IN THE DRAWINGS:

Examiner has objected to the drawings as failing to comply with CFR 1.84(p)(5).

Figure 5a**Figure 5b**

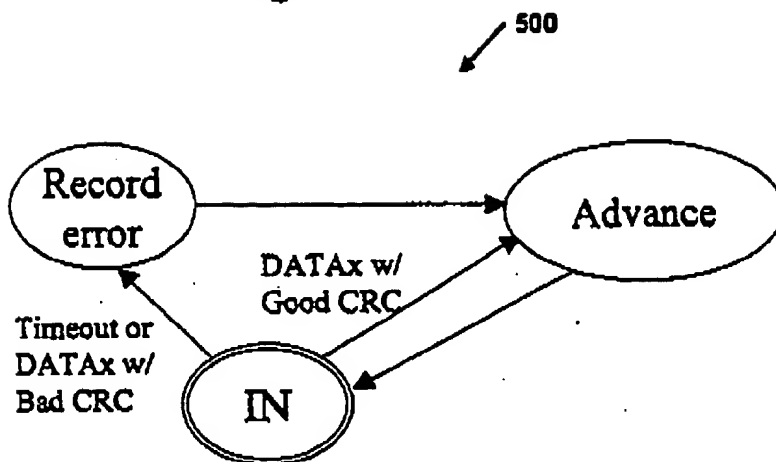
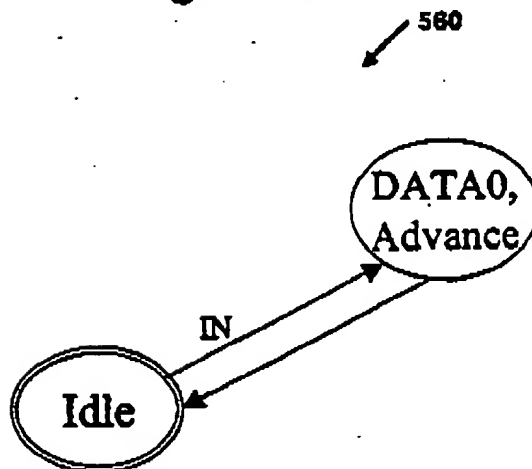
Applicants have submitted replacement figures for the Examiner's approval. Figures 1a, 6, 7, and 10d have been amended in accordance with Examiner's suggestions. References "101a" and "101b" have been added to figure 1a to refer to communication directions, upstream and downstream, respectively. References "601", "603-605", "607-609", and "611" of figure 6 and references "708", "709", and "711" of figure 7 have been deleted. Reference "705", however, was not deleted as it is referred to on page 23, line 21. Further, Applicants have amended the title of the figure under figure 4a to be "Figure 4b" (It was previously labeled "Figure 4a", also), and Applicants have amended the title of the figure under figure 5a to be "Figure 5b" (It was previously labeled "Figure 5a", also). This was done for consistency.
